B/M 101 072 136 & B/M 101 072 157 (50Hz)

EXIDE POWER SYSTEMS DIVISION		ASSEMBLY ANNUNCIATION I
EXIDE INCORPORATED		
REV. 101-072-136-1	REV. 101-072-157-1	REV. 400/500 P3, T3
REV. 101-072-136-1		REV. 101-072-157-1
REV. 101-072-136-1		REV. 101-072-157-1
REV. 101-072-136-1		REV. 101-072-157-1
REV. 101-072-136-1		REV. 101-072-157-1
REV. 101-072-136-1		REV. 101-072-157-1
REV. 101-072-136-1		REV. 101-072-157-1

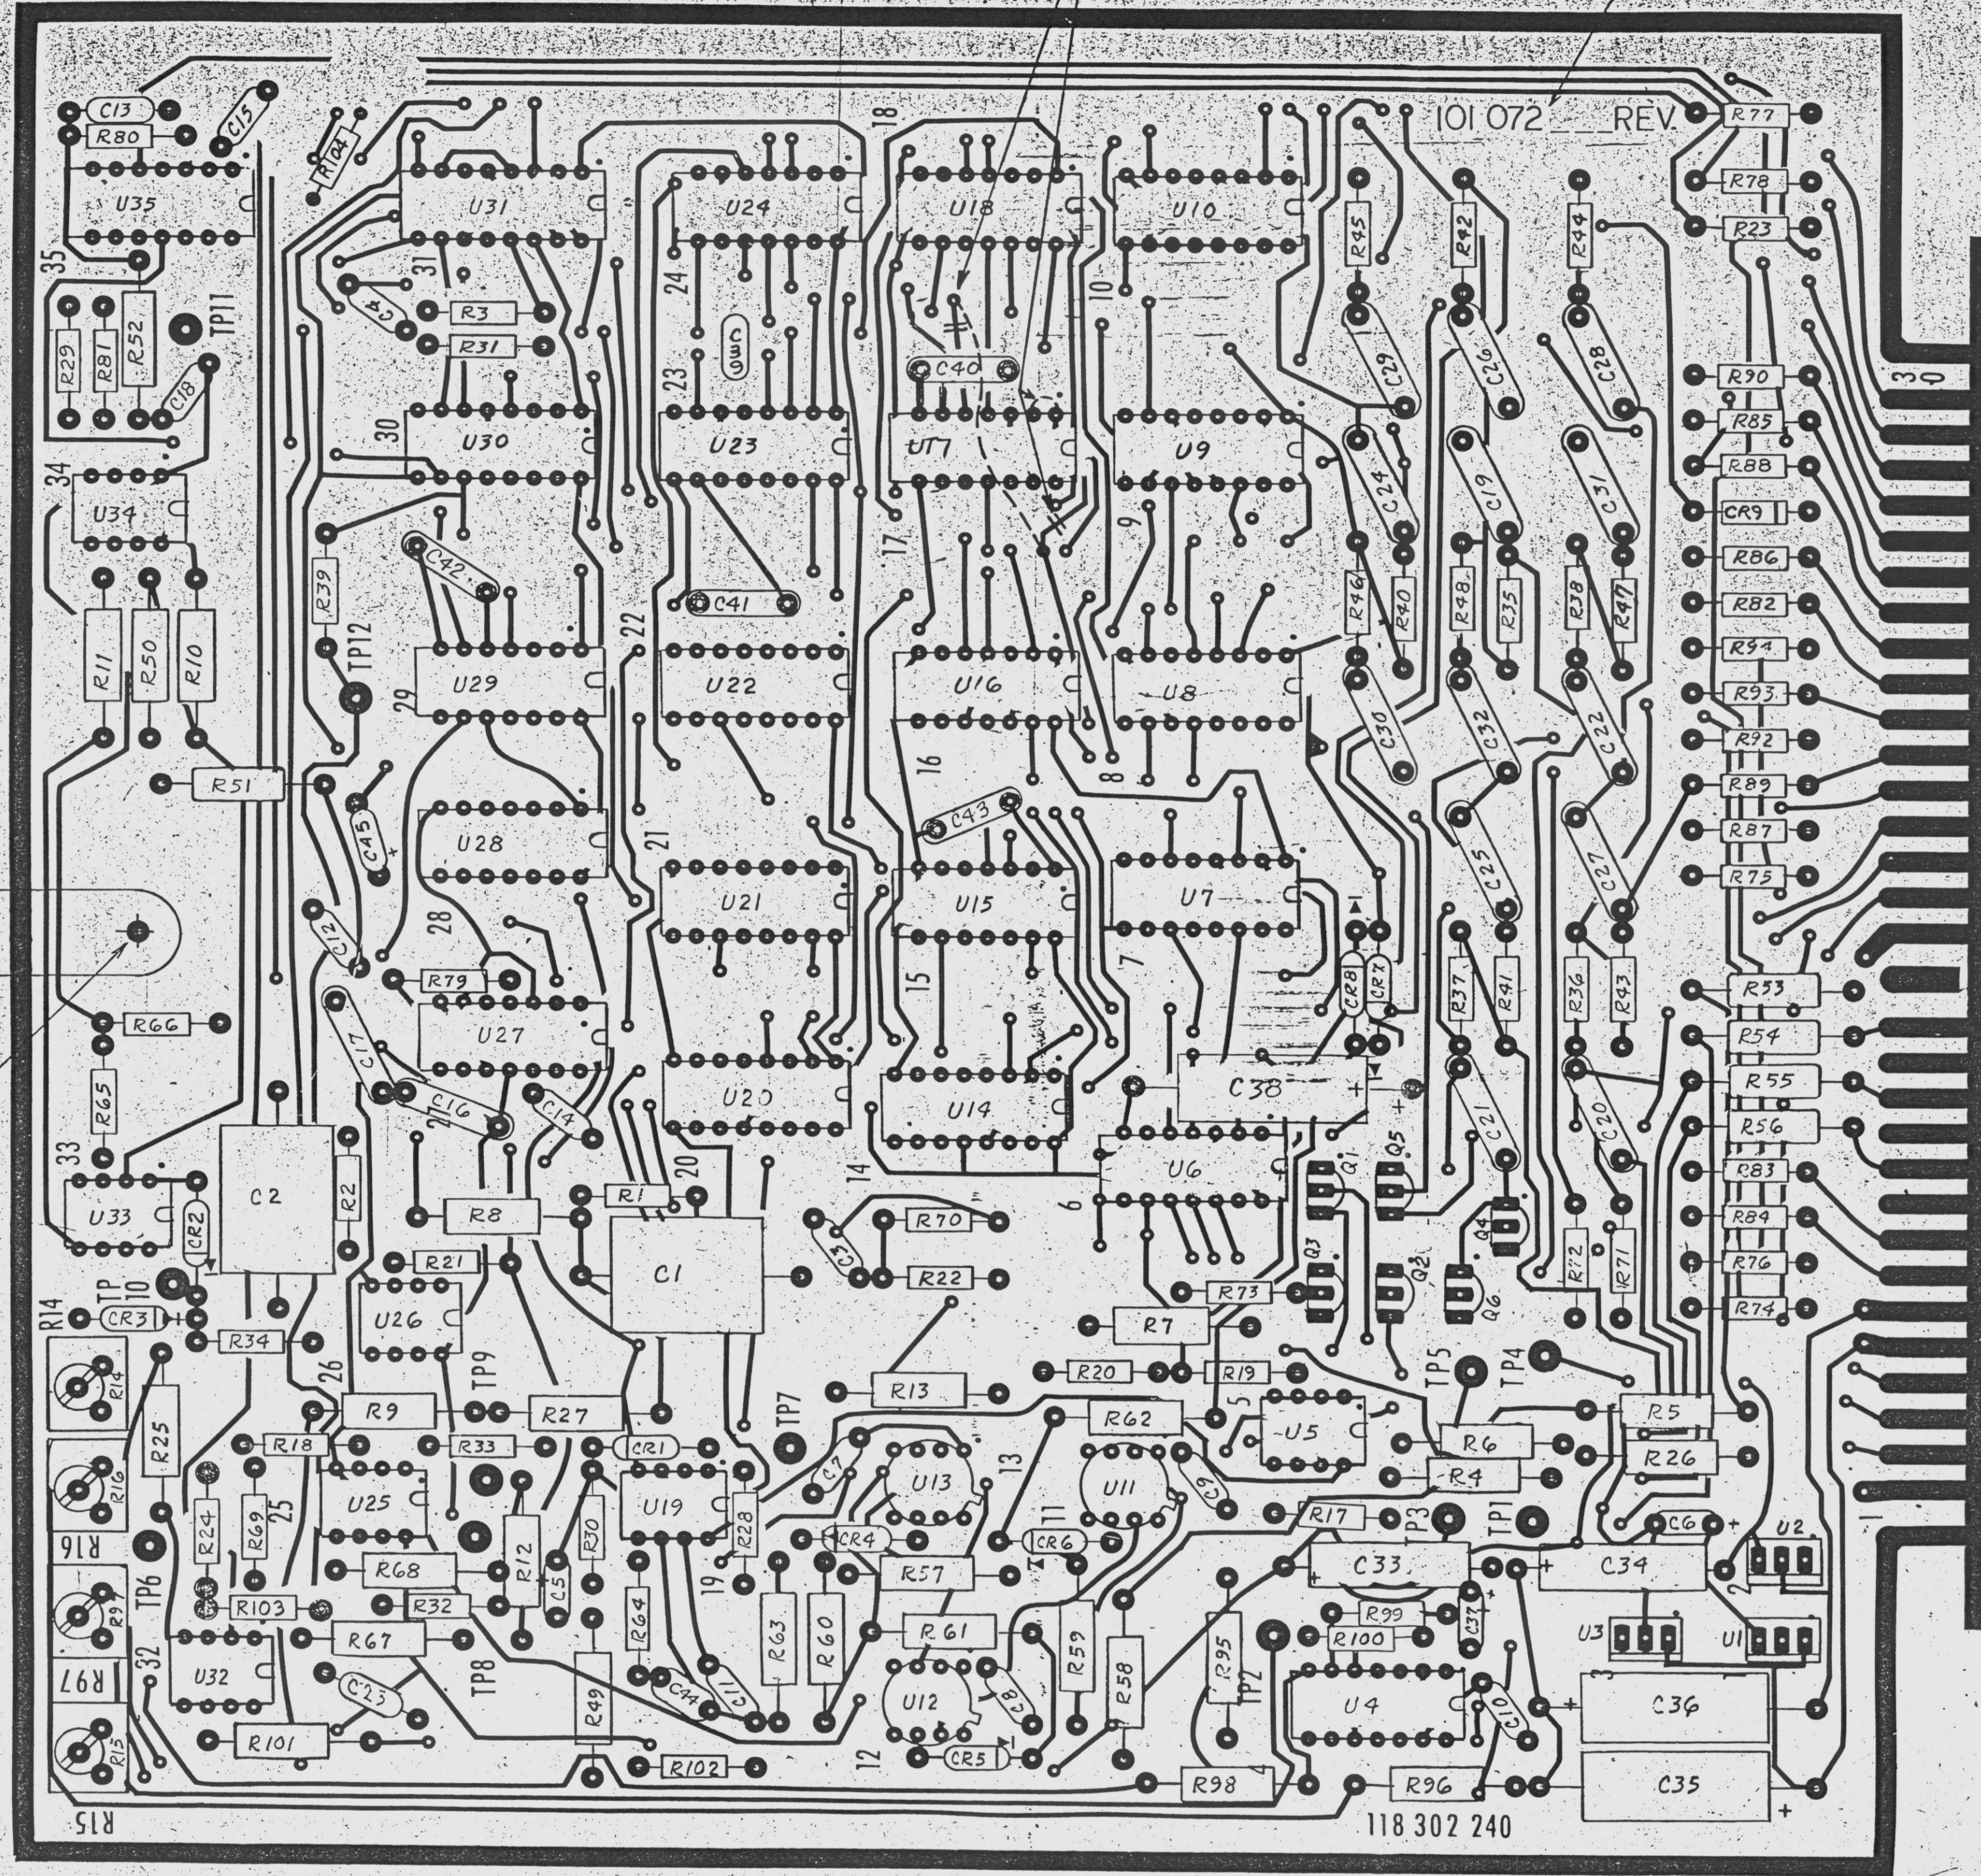
CUT TRACE (2) PLACES ON FRONT  
ADD #22 SOLID SLEEVED WIRE  
(2) PLACES ON BACK
